# *Final Value Engineering Study Report*

## *Widening of Hillcrest Parkway*

*CSSTP-0007-00(413), PI No. 0007413, Laurens County, Georgia*

Subject: Final Study Report  
**Widening of Hillcrest Parkway**  
City of Dublin, Laurens County, Georgia  
CSSTP-0007-00(413), PI No. 0007413

# VE ALTERNATIVE 9.0

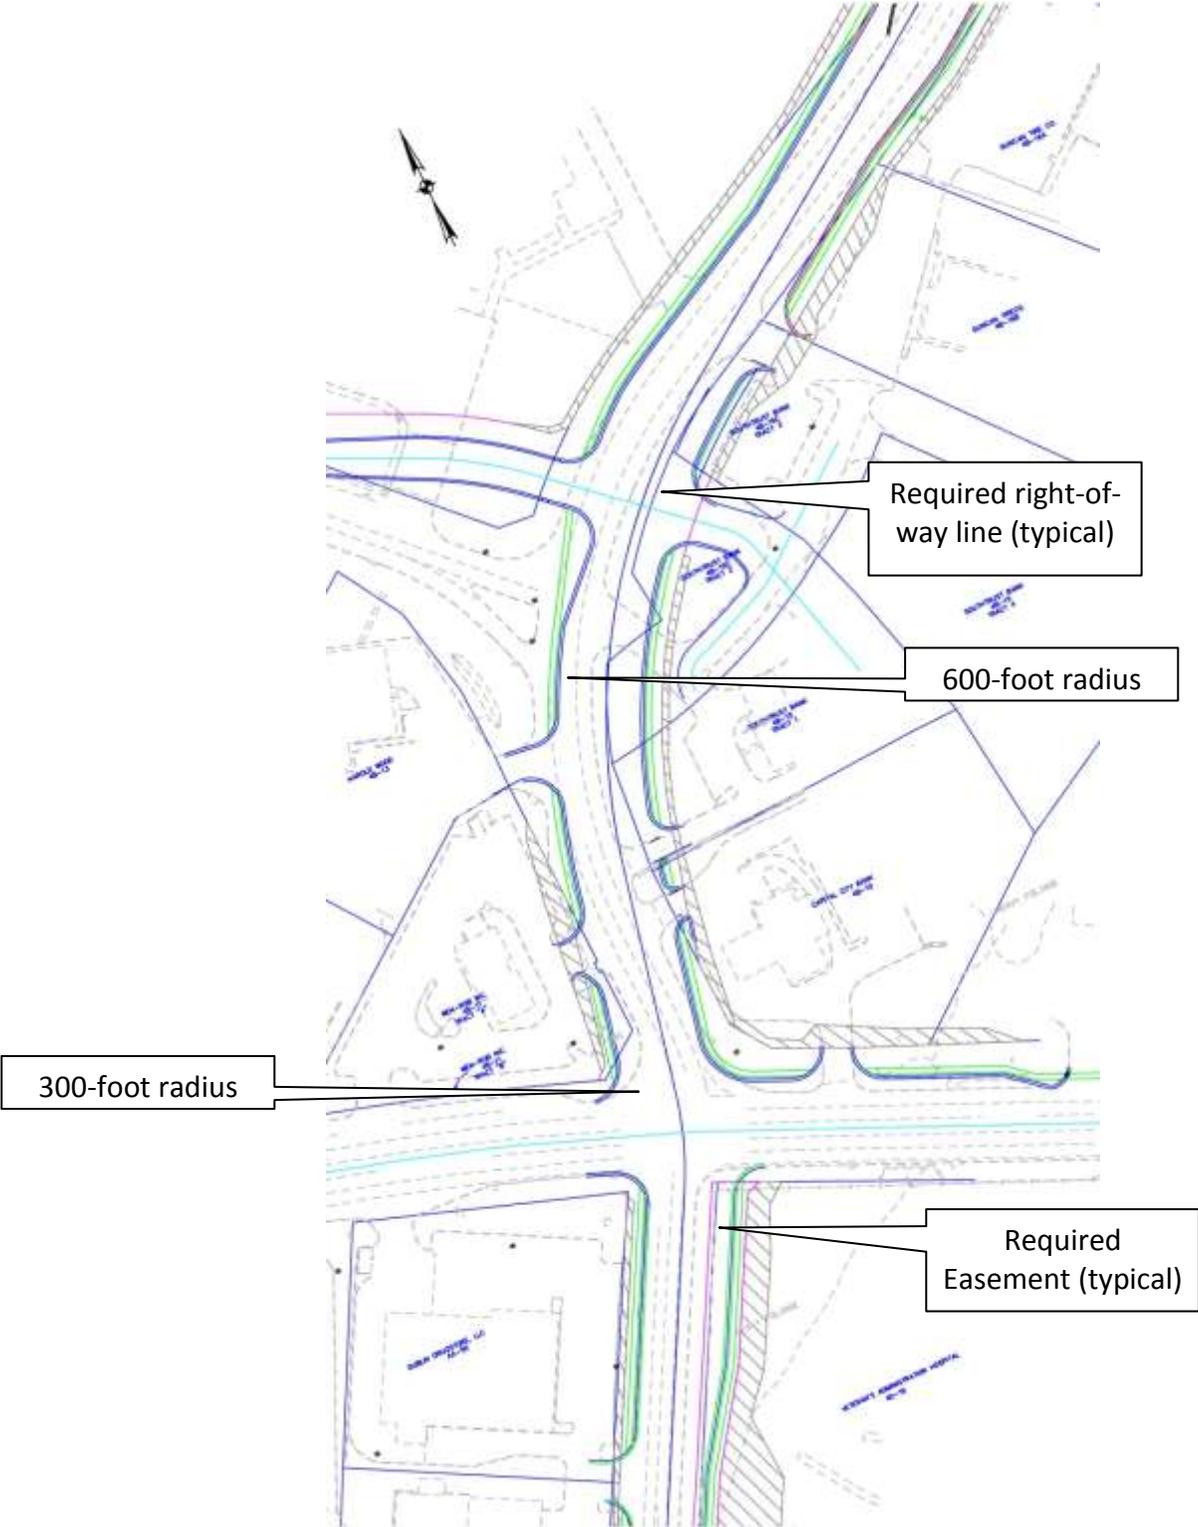
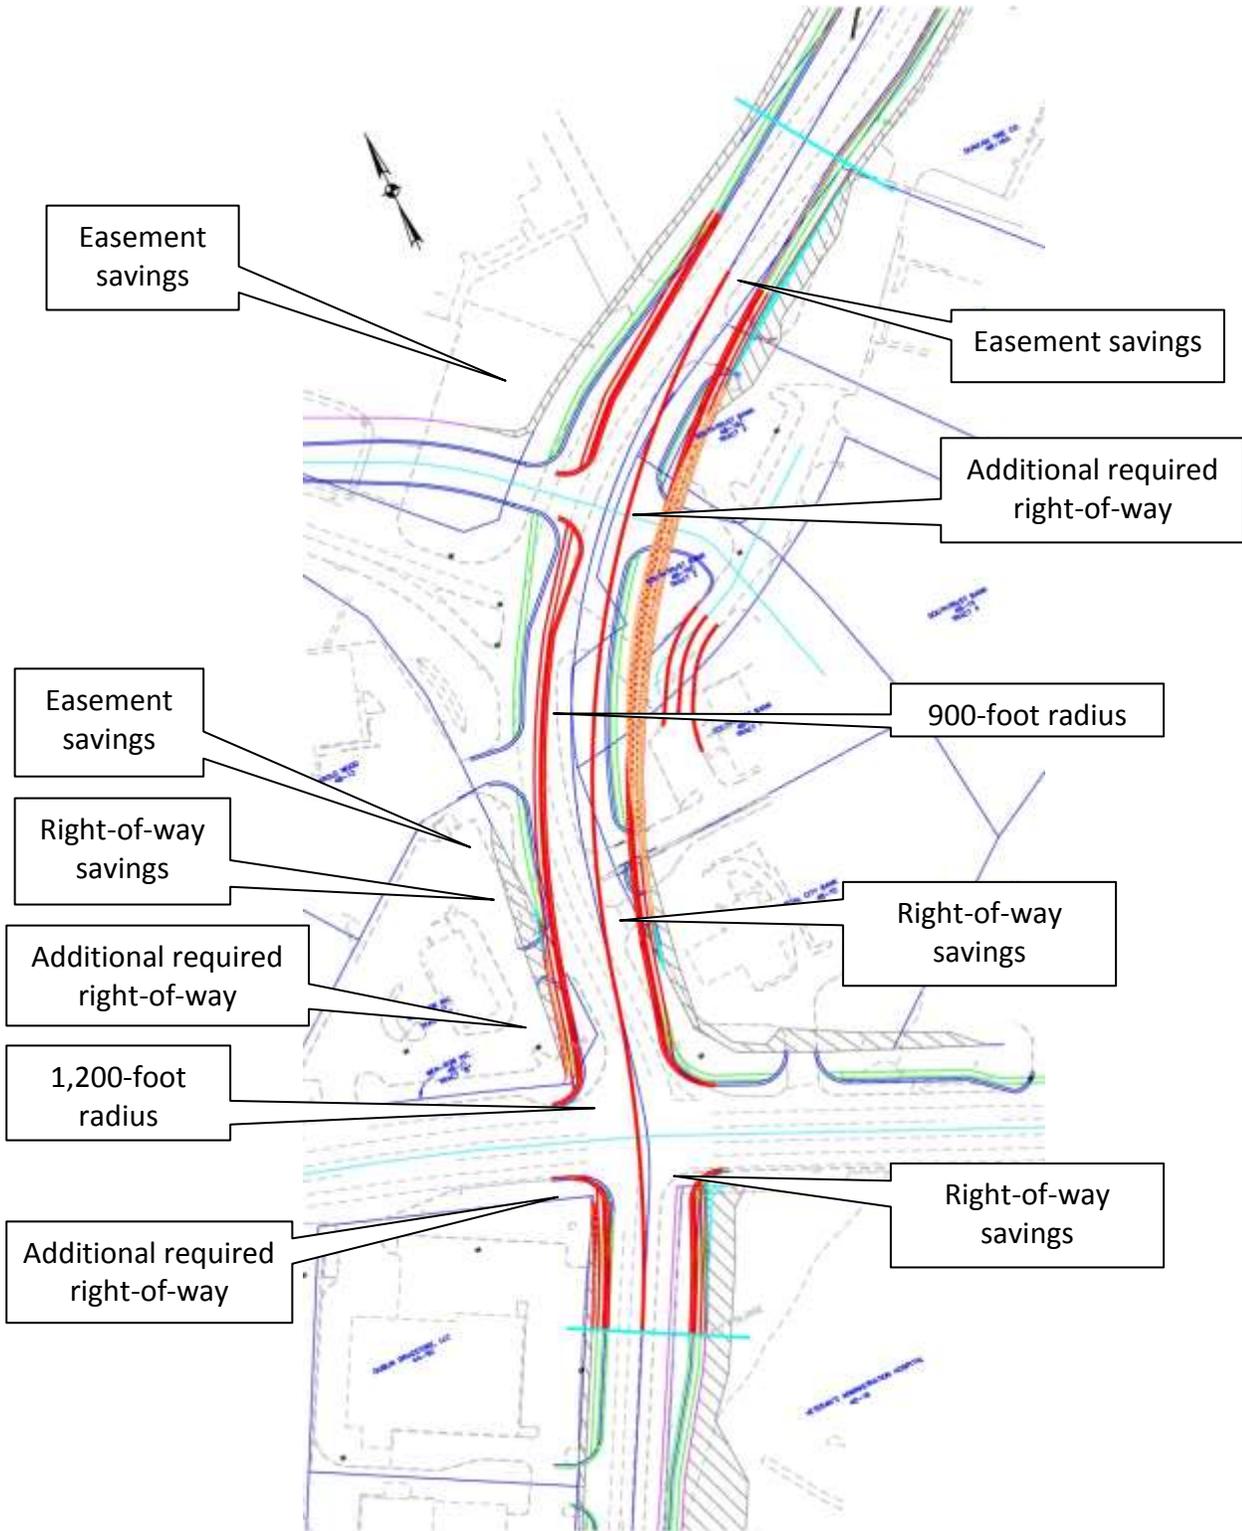
Knowing there are two design exemptions in the baseline concept, Alternative 9.0 enhances the baseline concept by increasing the westbound approach curve from a 600-foot radius to a 900-foot radius, therefore increasing the line of sight along Hillcrest Parkway in the vicinity of Shamrock Drive, the Dublin High School entrance to the north of Hillcrest Parkway, and four commercial entrance driveways along the south side of Hillcrest Parkway. In addition, the 300-foot radius that is located at the intersection of Hillcrest Parkway and US 80 has been increased to a 1,200-foot radius, which provides a flatter transition across the intersection and improves line of sight and driver expectancy in the overall intersection operations. In so doing, the horizontal alignment design exception would not be required; however, although the superelevation rate exemption is not eliminated, it is ameliorated.

The alternative alignment would revise the baseline concept centerline from approximately Station 44+75 to Station 56+00. All areas of right-of-way and easements required from Station 44+75 to Station 56+00 are measured from the 007413main.dgn file provided by the design consultant.
